**BROWNS FERRY NUCLEAR PLANT (BFN) - UNITS 2, AND 3 - AMERICAN SOCIETY OF MECHANICAL ENGINEERS (ASME) SECTION XI, INSERVICE INSPECTION (ISI) PROGRAM - REQUESTS FOR RELIEF 2-ISI-22, AND 3-ISI-18 FOR EXAMINATION OF REACTOR PRESSURE VESSEL (RPV) NOZZLE-TO-VESSEL SHELL WELDS AND NOZZLE INNER RADIUS SECTIONS - RESPONSE TO NRC REQUEST FOR ADDITIONAL INFORMATION (RAI) (TAC NOS. MC0167 AND MC0168)**

**TENNESSEE VALLEY AUTHORITY  
BROWNS FERRY NUCLEAR PLANT (BFN)  
UNITS 2 AND 3  
AMERICAN SOCIETY OF MECHANICAL ENGINEERS (ASME) SECTION XI,  
INSERVICE INSPECTION (ISI) PROGRAM  
REQUESTS FOR RELIEF 2-ISI-22 AND 3-ISI-18,  
RESPONSE TO NRC REQUEST FOR ADDITIONAL INFORMATION**

Figure 1 Cladding Residual Stress Data

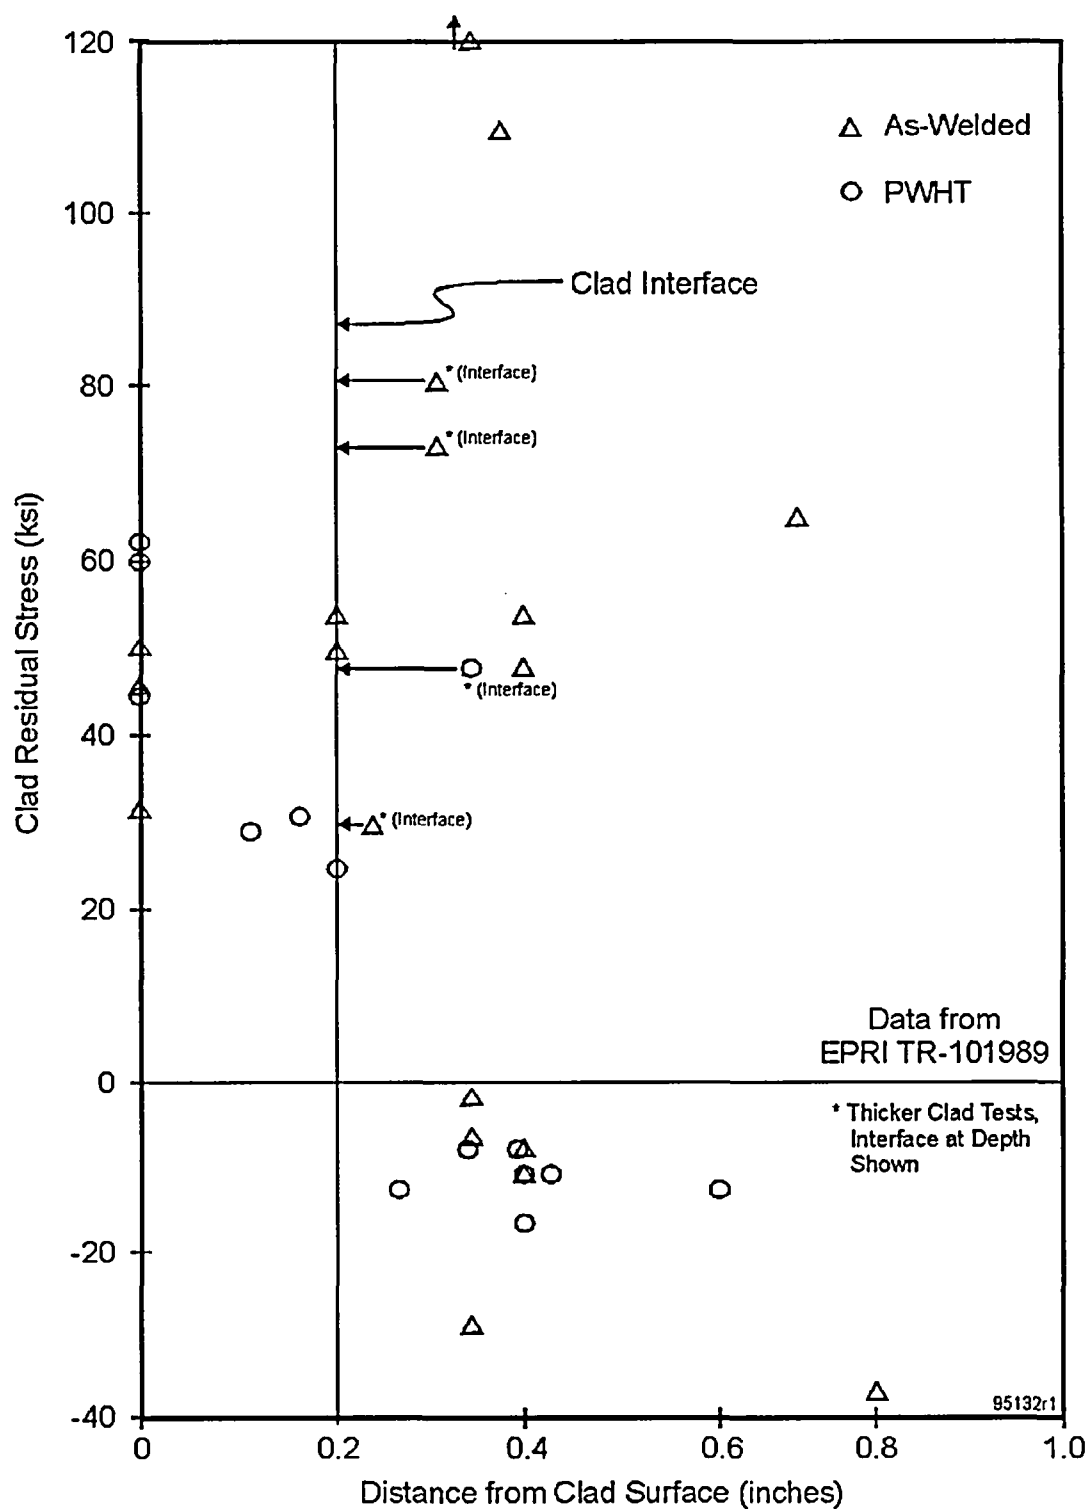
It is stated in Section 3.2 that "On BWR/6 RPVs, all nozzles except recirculation nozzles are unclad to improve the capability for inspection of the nozzle-to-shell welds by ultrasonic testing (UT)." Is cladding modeled in your finite element method (FEM) model for the RPV recirculation nozzle? Provide an assessment of the impact on the final probabilistic fracture mechanics (PFM) results if cladding is not modeled in the FEM model for the recirculation nozzle (Page 3-2).

In the probabilistic fracture mechanics (PFM) evaluation, the effect of the cladding residual stress is accounted for in the nozzle-to-shell weld evaluation. The residual stress due to the cladding is shown in Figure 1, [3]. The cladding residual stress is a random variable in the PFM evaluation. Therefore, the impact of the cladding as a residual stress effect is included in the evaluation for the nozzle-to-shell weld.

Figure 2 Comparison of Actual vs Design Startup Event

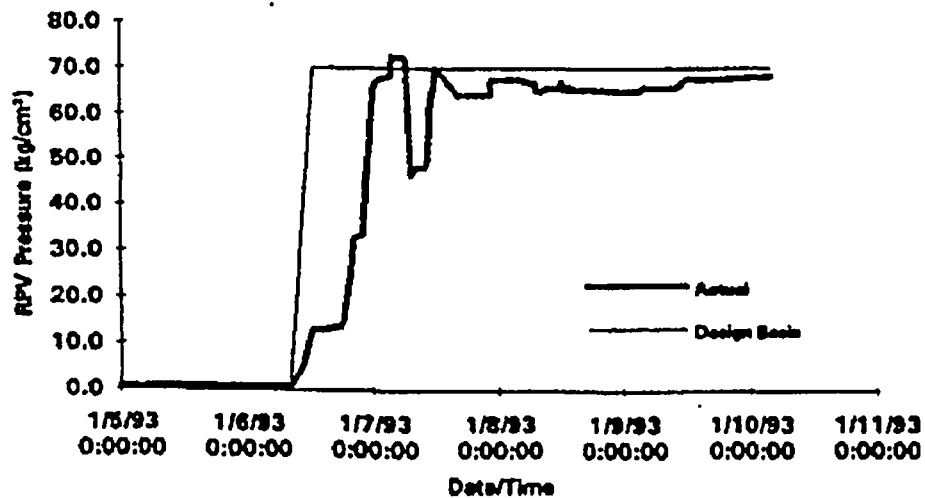
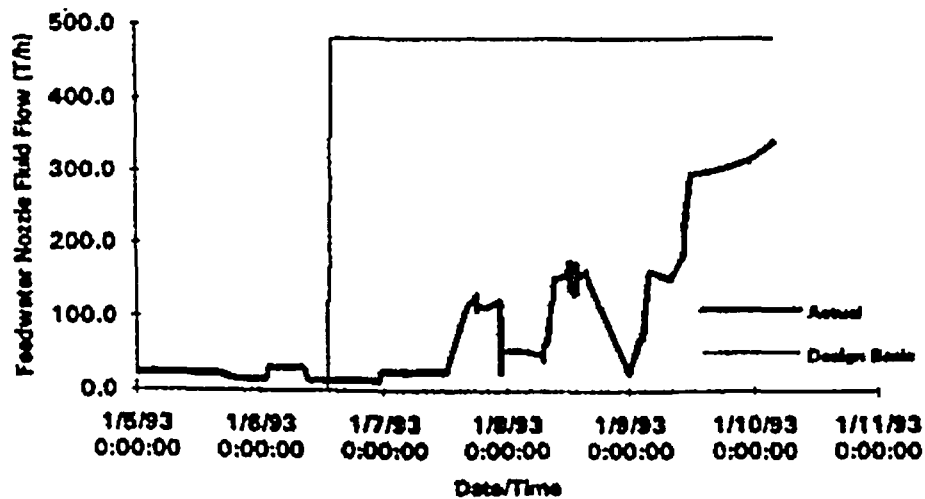
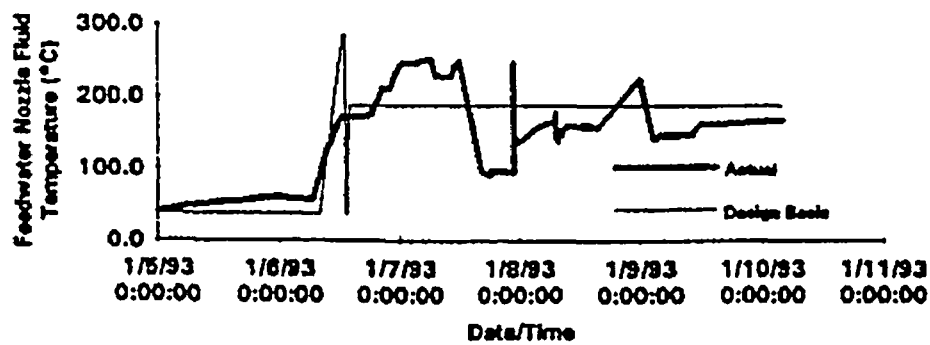
Justify your selection of the thermal loads for the four types of nozzles. Compare your idealized thermal loads shown in Figure 4-12 to Figure 4-20 with those from operating history of BWR plants and demonstrate that your selection is bounding (Page 4-4).

T. Sakai et al., and D. Pando et al., [18,19] observed, based on comparison of actual measured temperature (using fatigue monitoring systems) that actual transients are much less severe than those assumed in the thermal stress analyses, Figures 2 through 4. Therefore, the selection of transients is considered appropriate and conservative for this analysis.

Figure 5 Nozzle Hoop Stress, Longitudinal Section, Internal Pressure [6]

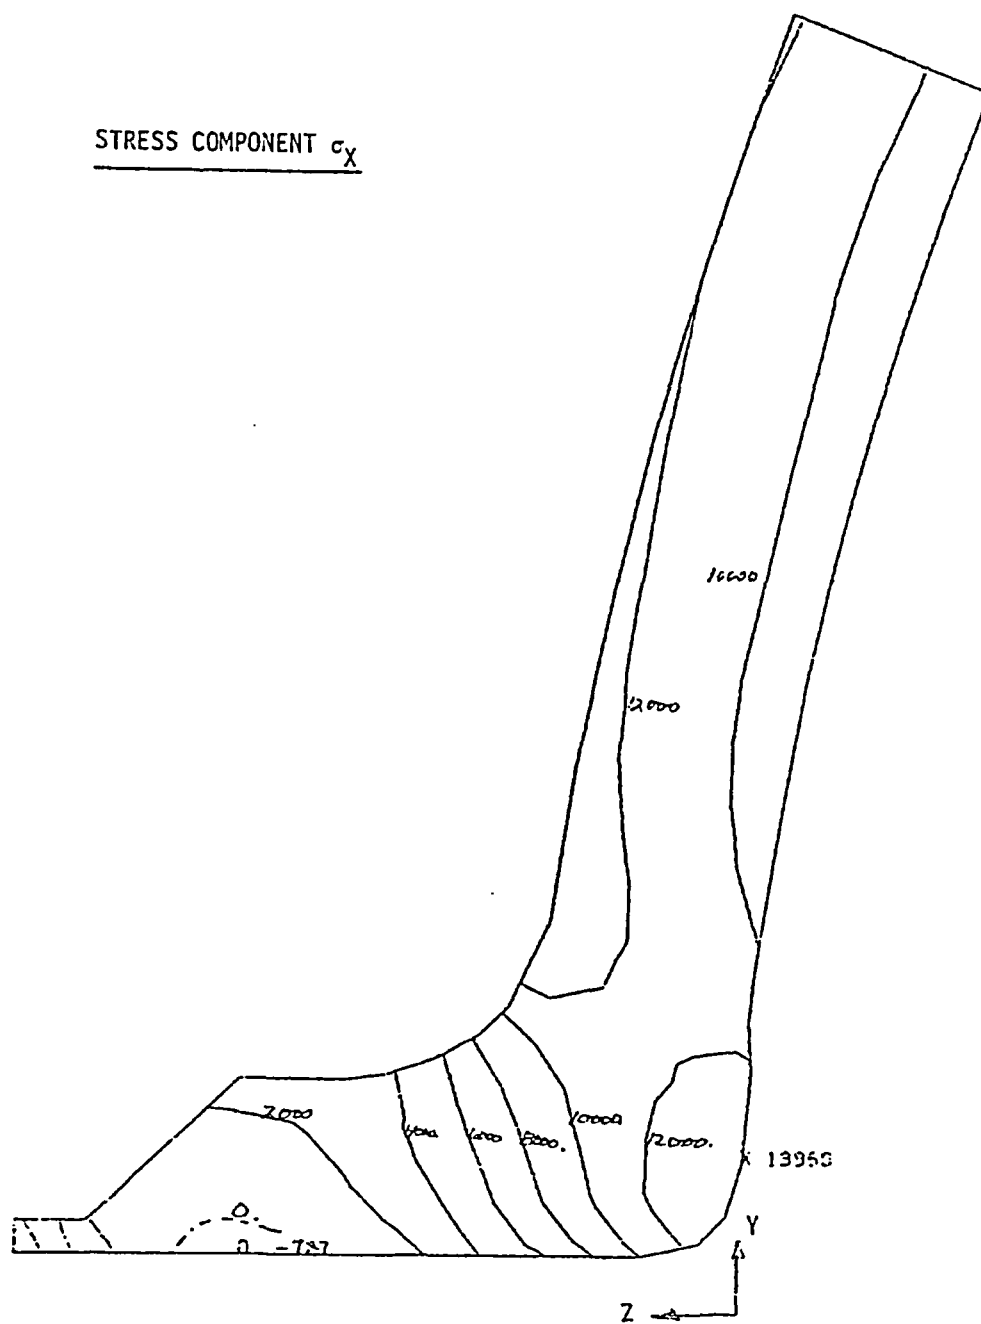
Figures 4-30 through 4-37 show the stresses for the blend radius and the nozzle-to-vessel shell weld for the four types of nozzles. Explain (1) why the pressure-induced hoop stress varies so much azimuthally, considering that the nozzle hole in the vessel will have similar effect on all azimuthal positions, especially when the typical angular distance between the nozzle and the edge of the FEM model is about eight times the diameter of the nozzle and (2) why the hoop stresses at nozzle blend radius are significantly worse than those at the nozzle-to-shell weld. This serves as a check of your FEM modeling accuracy (Page 4-5).

Three-dimensional finite element analyses have been performed for nozzle stresses due to pressure and thermal loadings, [6,7]. They show significant stress variation at the azimuth locations. Figures 5 and 6 present the hoop stress at the longitudinal plane and the transverse plane, respectively, of a nozzle subjected to an internal pressure [6]. The maximum hoop stress at the nozzle blend radius in the longitudinal plane, Figure 5, is higher than the hoop stress at the nozzle blend radius in the transverse plane, Figure 6.

Figure 12 Nozzle Corner Crack

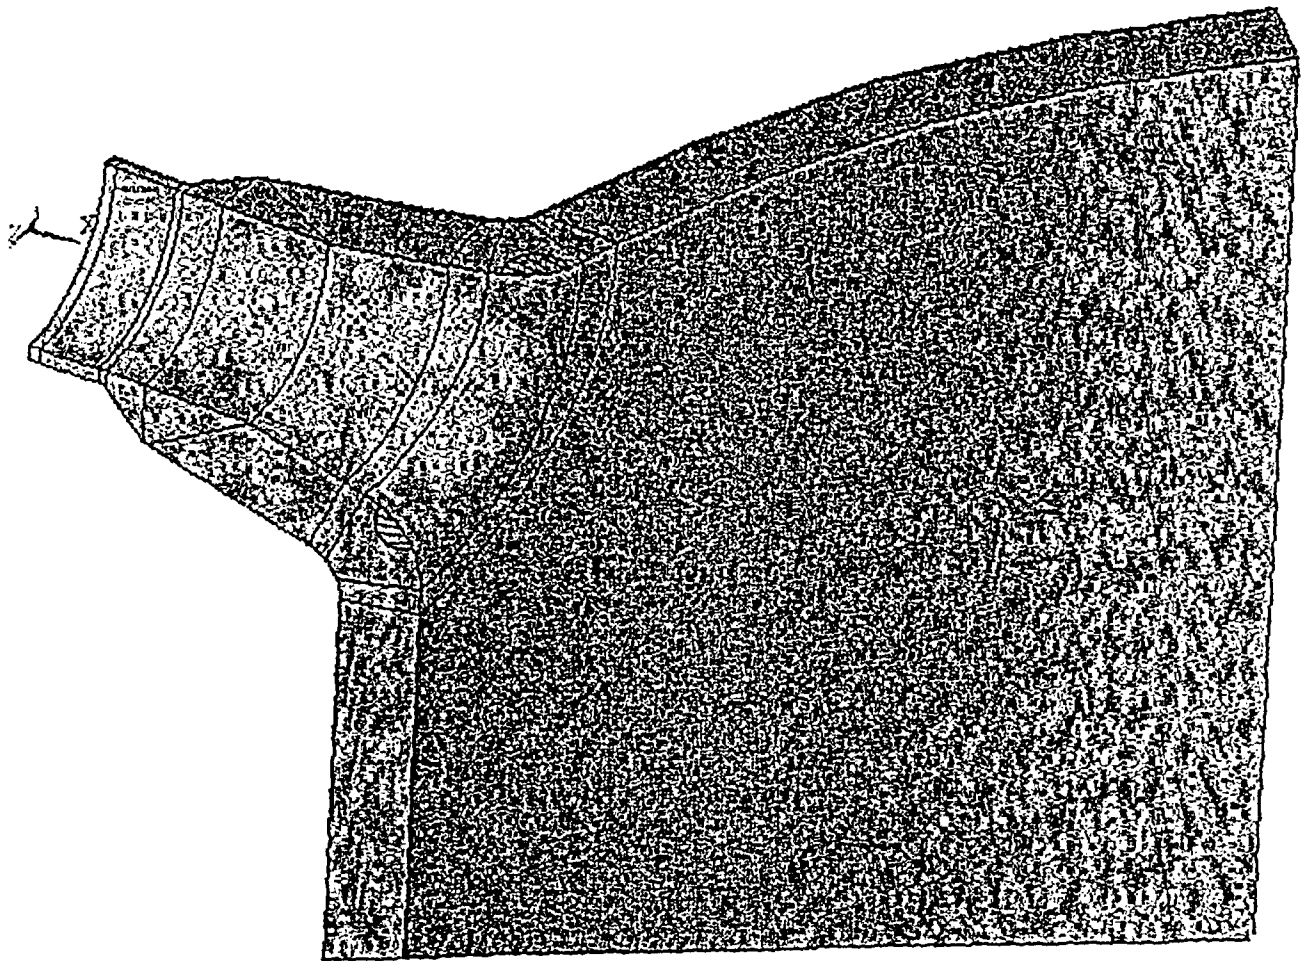
The assumed cracks are described in the statement, "The fracture mechanics evaluation presented in Sections 5 and 6 considers flaws either parallel or perpendicular to the nozzle-to-shell weld location. The evaluation considers an axial flaw at the nozzle blend radii." Provide schematics of these three types of flaw (location and orientation) in Figure 4-1 (Page 4-6). Also, provide test and service data supporting the assumed aspect ratio of 2 to 1 for all flaws before and during the crack growth (Page 5-6).

The nozzle corner crack is at the nozzle blend radius region. This nozzle corner crack model is illustrated in Figure 12. This nozzle corner crack can be at any azimuth angle in the nozzle. Therefore, when it is initiated at the transverse plane of the reactor vessel, it is in the circumferential orientation with respect to the vessel transverse plane. When it is initiated at the longitudinal plane of the reactor vessel, it is in the longitudinal orientation with respect to the vessel longitudinal section. If using a local cylindrical coordinate with the longitudinal axis along the centerline of the nozzle, the normal to

Figure 14 Cladding Stress Corrosion Crack Initiation Data

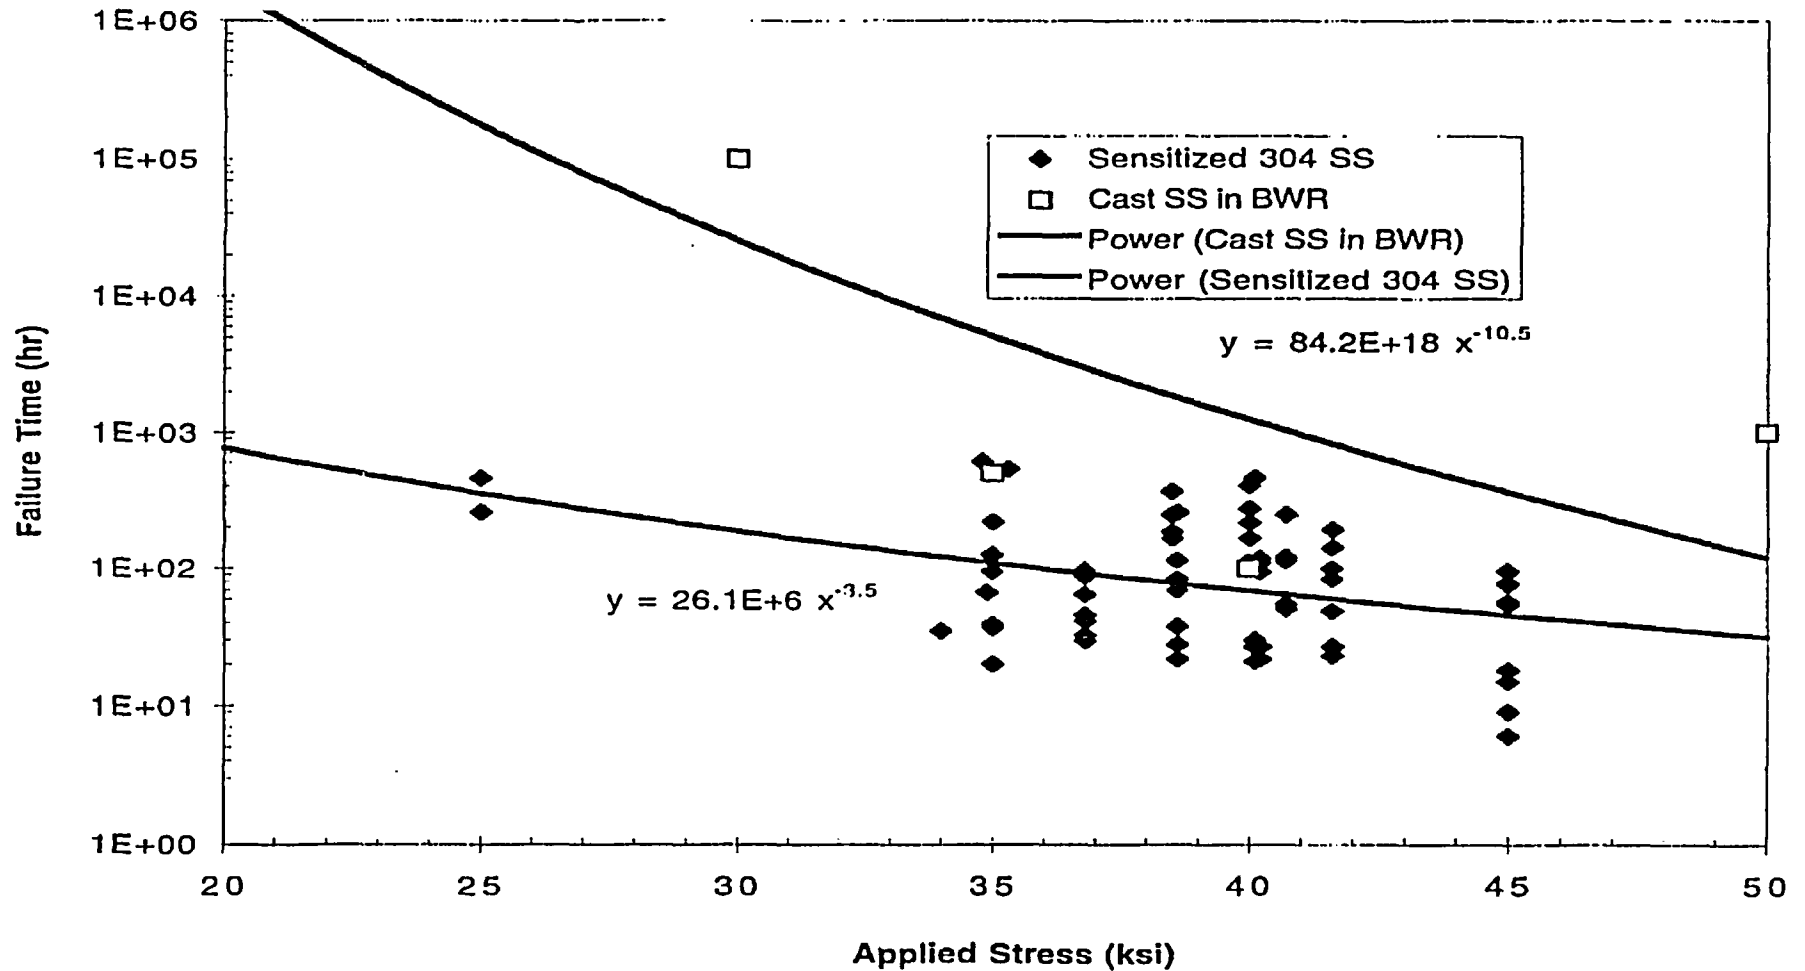
A figure showing all test data (additional data plus the original five pertinent to BWRVIP-05) with the fitted curve representing the stress corrosion initiation equation of Table 5-1.

The stress corrosion initiation equation is obtained from Reference 3. This equation is developed based on data shown in Figure 14 [3].

The following is an excerpt from BWRVIP-05 [3] on the data evaluation. Note that Figure 8-4 from BWRVIP-05 is reproduced as Figure 14 in this RAI response.

“Cladding stress corrosion crack initiation data were obtained from existing literature, and from estimates based on field experience with stainless steel weld metal and casting cracking. These data are illustrated by the open squares in Figure 8-4, in terms of time to failure (assumed to be crack initiation) versus applied stress. These data are relatively sparse, which is indicative of the strong resistance of this material to stress corrosion cracking. Nonetheless, some field cracking has been observed, which is collectively represented by the single point at 30 ksi and  $1 \times 10^5$  hours to failure. Conversely, a great deal of data is available for wrought sensitized stainless steel in the BWR environment, as indicated by the solid diamonds in the figure. For purpose of this study, best-fit curves were developed for both sets of data, with the cast/weldment curve, as expected, falling well above the wrought curve in terms of time to failure. In order to characterize the statistical variability of the data, a log-normal fit was developed for the wrought data relative to its best-fit curve, which distribution was also assumed to be applicable to the cast/weldment curve. That is, it was assumed that, if sufficient cast/weldment data

Figure 15 Comparison of Fatigue Crack Growth Laws

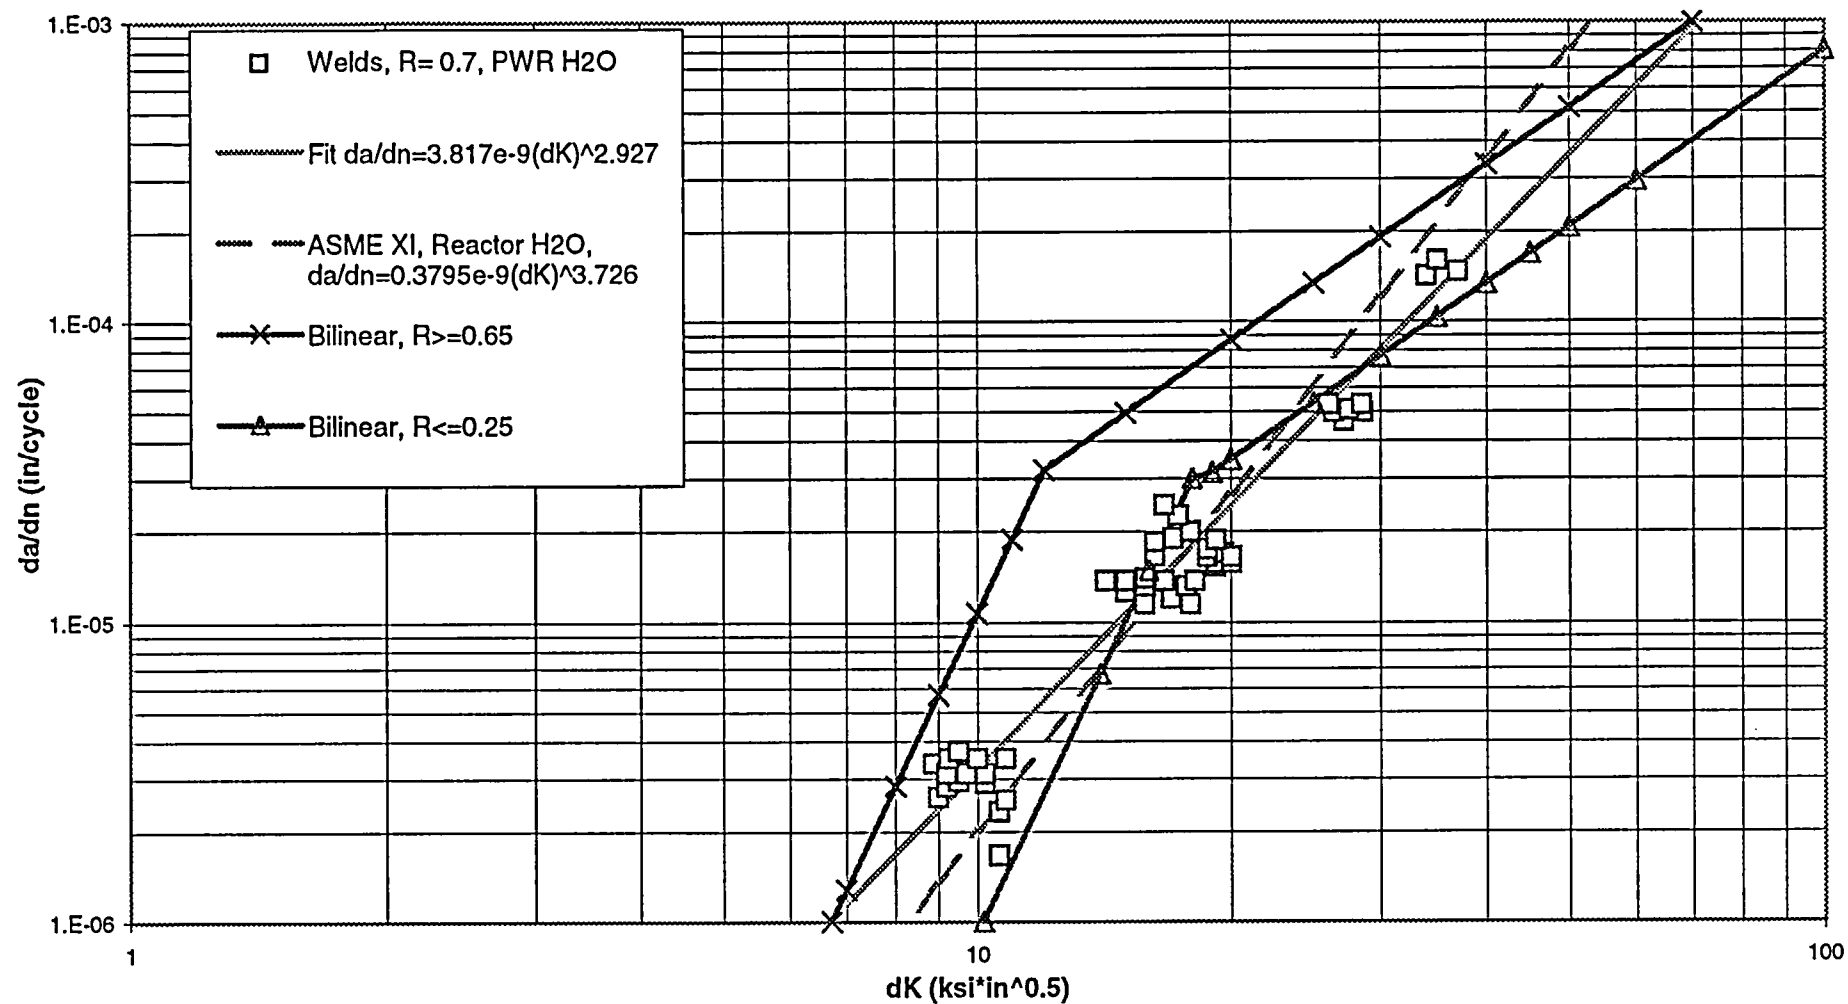
Justification for using a fatigue crack growth rate based on limited data as shown in Figure 5-1.

In the current evaluation, a fatigue crack growth law along with its distribution is derived using a subset of the original data that were used to formulate the Section XI fatigue growth laws. The derived fatigue crack growth correlation is compared to the ASME 74' linear and 86' bilinear crack growth laws, Figure 15. This shows a very reasonable comparison. In addition, from the PFM results,
